KITTELSON & ASSOCIATES Oakland Latitude School 29th Ave Driveway Restriction Oakland, California

FOR GO 88-B PERMITTING

Oakland Latitude School Off-Site Design Oakland, California

Oakland Latitude School 29th Ave Driveway Restriction Oakland, California

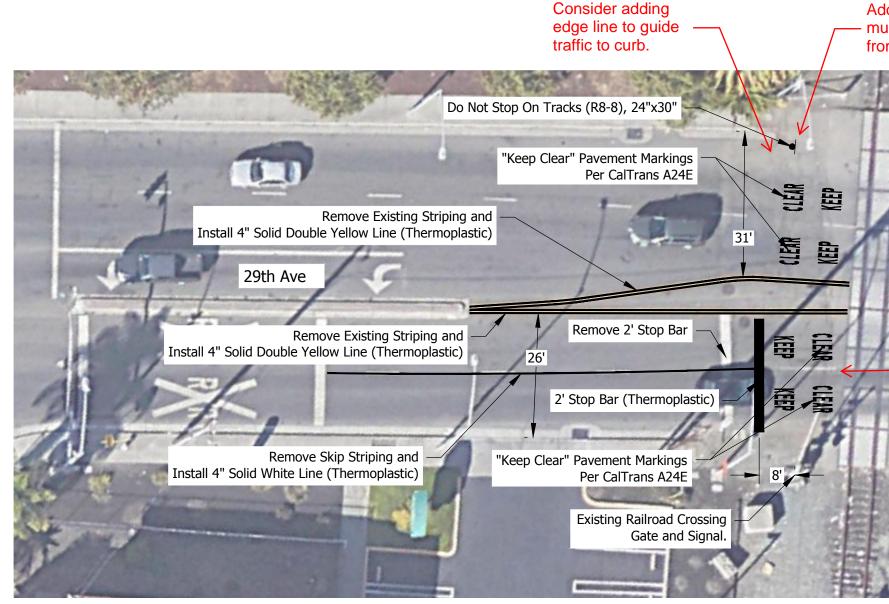
Add note that R8-8 sign must be at least 10' from centerline of track.
